Industry/TSTF Standard Technical Specification Change Traveler**Provide Actions for One Steam Supply to Turbine Driven AFW/EFW Pump Inoperable**

ISTS 3.7.5, Auxiliary Feedwater (BWO: Emergency Feedwater), is revised to address the condition of one or two motor driven AFW/EFW trains inoperable and the turbine driven AFW/EFW train inoperable with one steam supply inoperable.

TSTF-412

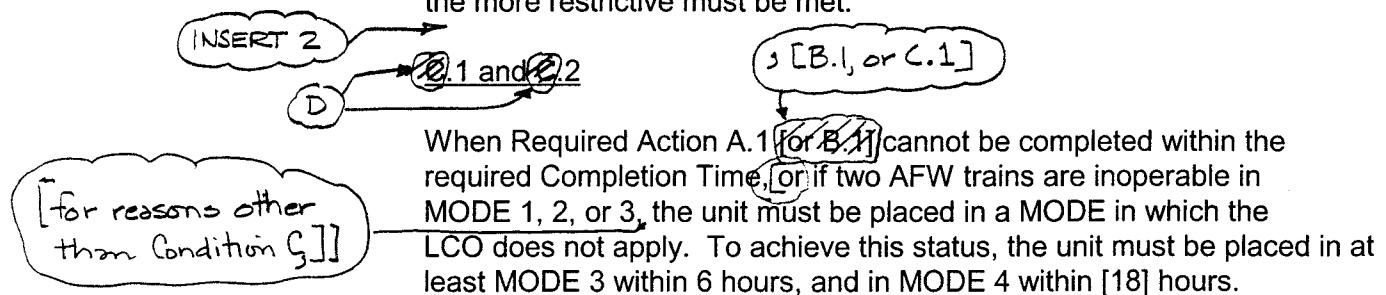
Condition A is modified by a Note which limits the applicability of the Condition to when the unit has not entered MODE 2 following a refueling. Condition A allows one AFW train to be inoperable for 72 days vice the 72 hour Completion Time in Condition B. This longer Completion Time is based on the reduced decay heat following refueling and prior to the reactor being critical.]

Insert 2 (WOG)[C.1

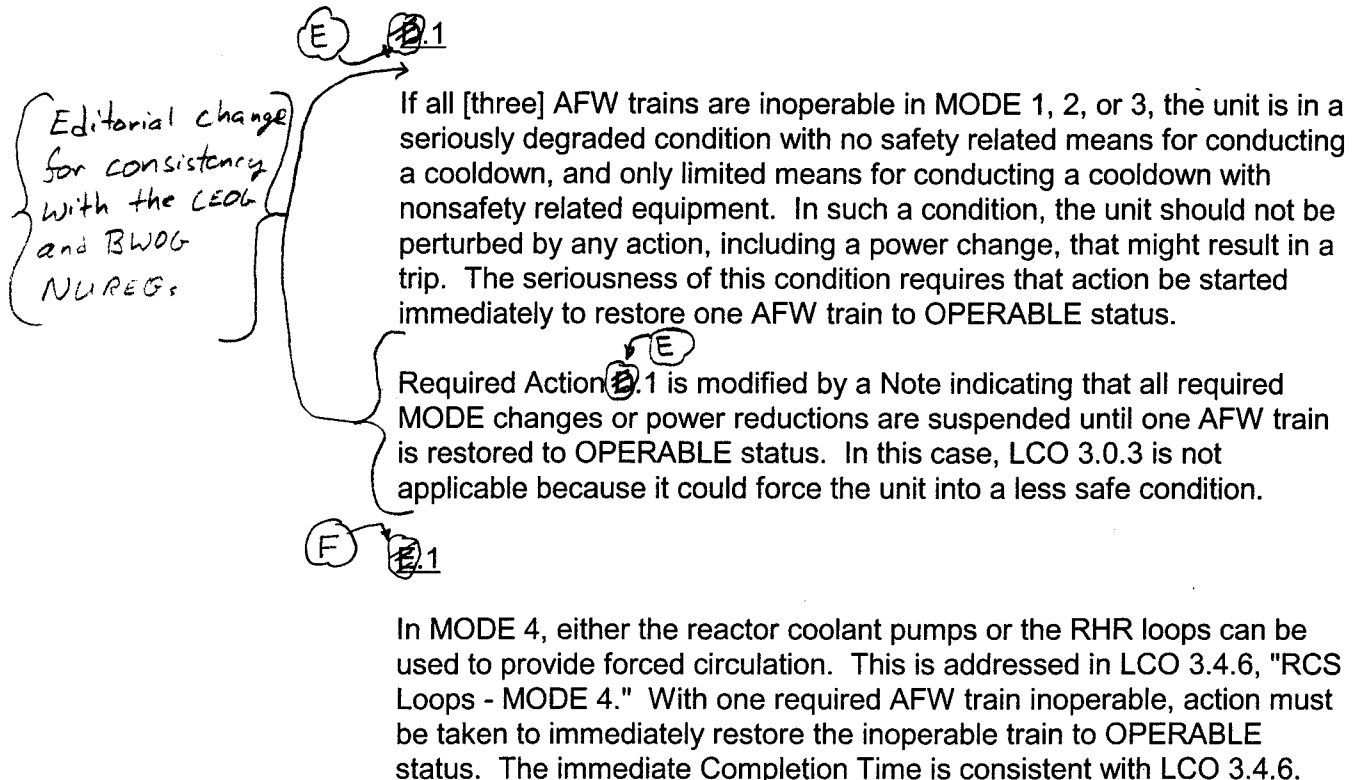
The following Condition may be applied provided that the AFW System design basis can be met, excluding consideration of a single failure. For four and three loop plants, the remaining OPERABLE motor driven AFW train must be capable of feeding two intact steam generators. For a two loop design, the remaining steam generator must be capable of being fed by a motor driven AFW train. If the design basis cannot be met given all combinations of inoperable steam supplies, motor driven AFW trains, and faulted steam generators, the following Condition must be modified by a Note such as the following: "The inoperable motor driven AFW train and the inoperable steam supply must not defeat the delivery of the required AFW flow to the required intact SGs."

With one of the required AFW trains (pump or flow path), which includes a motor driven pump, inoperable, and the turbine driven AFW train inoperable due to one inoperable steam supply, action must be taken to restore the affected equipment to OPERABLE status within 24 hours. This Completion Time is reasonable, based on the redundant OPERABLE steam supply to the turbine driven AFW pump, the availability of the remaining OPERABLE motor driven AFW pump, and the low probability of an event occurring that requires the inoperable steam supply to the turbine driven AFW pump. [This Condition is modified by a Note stipulating that the inoperable motor driven AFW train and the inoperable steam supply to the turbine driven AFW pump must not defeat the delivery of the required AFW flow to the required intact SGs, assuming a fault in any SG, but not assuming a single failure due to the Completion Time limitation of the Condition.]]
